Active Travel Consultation – Pop-Up Lanes

January 2023

Please find the below submission in response to the latest 'Active travel consultation'.

In response to the latest 'Active travel' consultation, Liverpool University Hospitals Foundation Trust (LUHFT) has engaged participants of the ATSEF (Active Travel Stakeholder engagement Forum), local community cycling clubs such as 'Aigburth Cycle Club' and 'Joyriders', members of the public and NHS staff.

Junction of Princes Avenue, Kingsley Road, and Croxteth Road

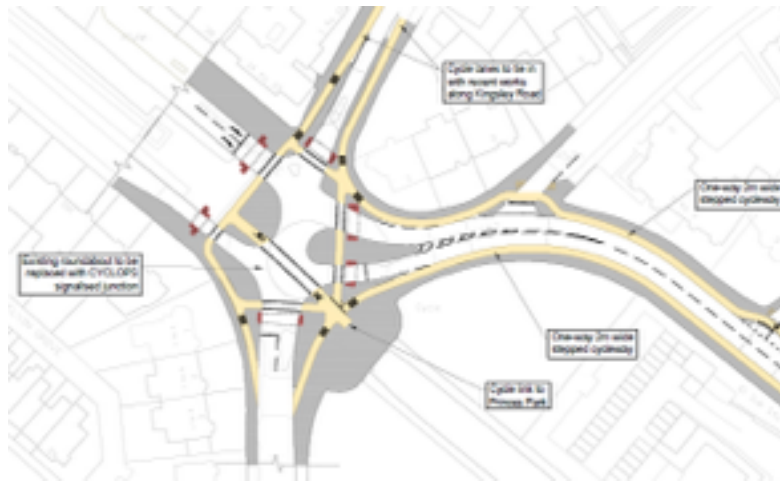
This is a very good junction, which allows cyclists and pedestrians to travel to and from all directions and allows cyclists to follow their desire line directly between Princes Park and Princes Avenue. The narrowing of carriageways on the approach helps to calm traffic speeds, which is very welcome.

However, it seems to rely on the proposed AI signals to be effective at changing the lights when cyclists approach. It may be less expensive and almost as effective, to install a Dutch Roundabout with priority for cyclists:

This would allow cyclists to continue through the junction without stopping, while allowing the same basic layout of the junction to remain. We believe that the geometry would work and that this could be cheaper than the current proposal to build and maintain, which could allow more to be spent on protecting cyclists and pedestrians at busier junctions. A roundabout without priority for cyclists may also be feasible if sufficient refuges are provided. We encourage Mott MacDonald to conduct a study to determine if signals are necessary at this junction.

Junctions at Kingsley Road, Upper Parliament Street, and Crown Street

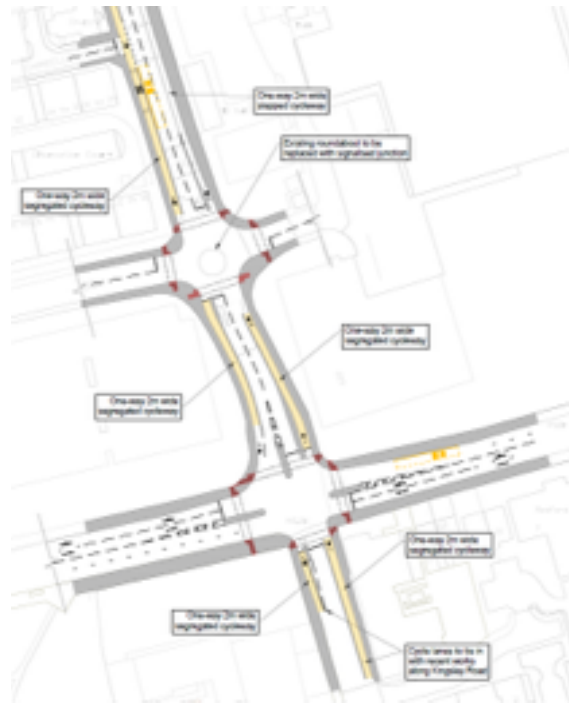
The level of protection given to cyclists across Upper Parliament Street is poor for the traffic volumes - early release at the traffic lights should be a minimum, and ideally a full Cyclops junction here would consider all potential directions of travel for cycle traffic.

The signalised junction at the entrance of the Liverpool Women's Hospital and JF Renshaw sites on Crown Street may not be necessary if usual traffic volumes in and out of these sites are low. It may be sufficient to treat these site entrances as minor roads and provide design safety for cyclists and pedestrians by installing continuous pavements and cycleways (design priority) across these side roads. Due to the 24-hour nature of the hospital, we suppose that there are less likely to be large surges of traffic at rush hour compared to other large employment centres. We'd encourage Mott MacDonald to study the traffic patterns and reconsider if there are alternatives to signalisation if AI camera control is not feasible.

Example Cyclops in Manchester (left) and possible solution for junction at Women's Hospital (right).

Crown Street Park

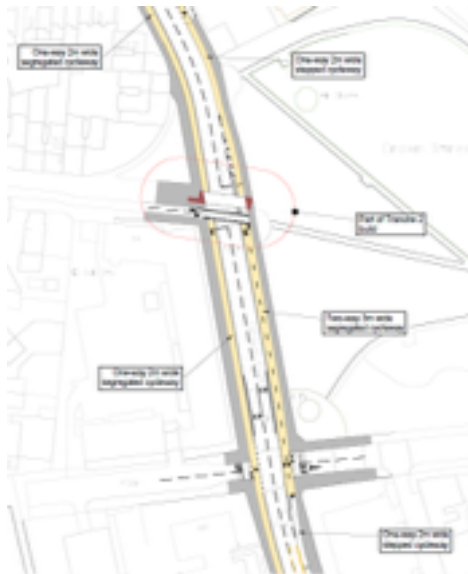
The plan around Crown Street Park needs some reworking- it seems unnecessary to have a unidirectional and a bidirectional cycle path on the same street. The right turn from Falkner Street into the bidirectional cycle path on Crown Street seems to create a conflict with drivers by being unexpected. We would recommend creating an unsignalised major to minor junction with refuges and design priority for cyclists grouped with an informal crossing for pedestrians, to allow both to cross Crown Street while taking each traffic lane in turn.

The bidirectional cycle lane and crossing between Myrtle Street and Crown Street Park is in practice often used as a waiting area for pedestrians, and there is often conflict between pedestrians and cyclists at the entrance to the park due to the narrow gateway. Either there should be a secondary gateway and path for cyclists to pass through the park, or cyclists should be intentionally directed away via Faulkner Street - currently cyclists use both routes because the design tends to funnel cyclists towards the park, but during termtime rush hour the paths through the park are usually too full of pedestrians to feasibly be shared.

West Derby Road Shops

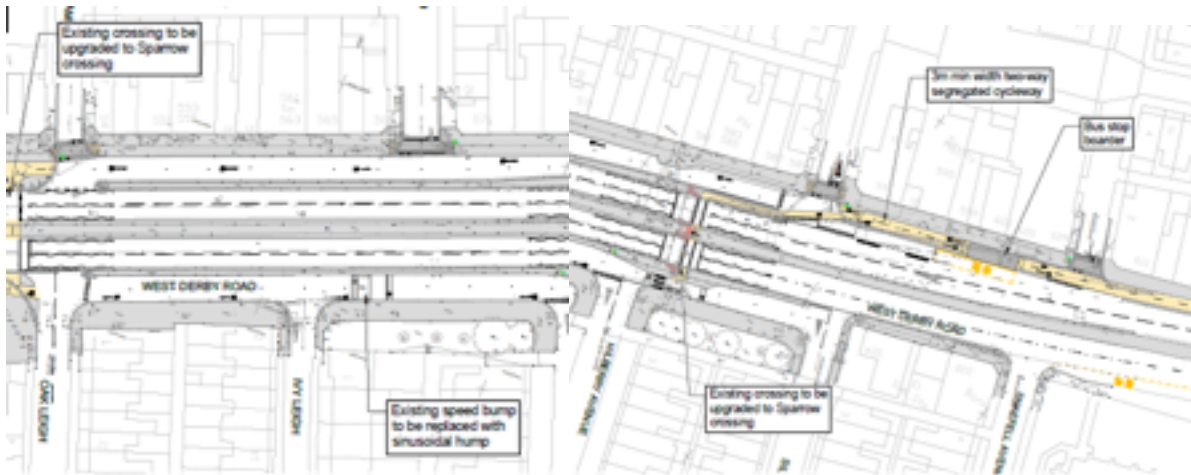
On low traffic volume residential streets, the use of access streets can be suitable as a shared space between motor and cycle traffic. However, Crash Map already shows many collisions between vehicles at entrances and exits of this access street at the front of the row of shops.

We think it would be very risky to put cyclists in this space without further modification - at a minimum serious traffic calming would be necessary, or ideally the permanent cycleway would pass through a new pedestrian area. This could also be an opportunity to provide some good quality public space on a local high street and parking could be on West Derby Road making it easier for people to access the shops from their cars.
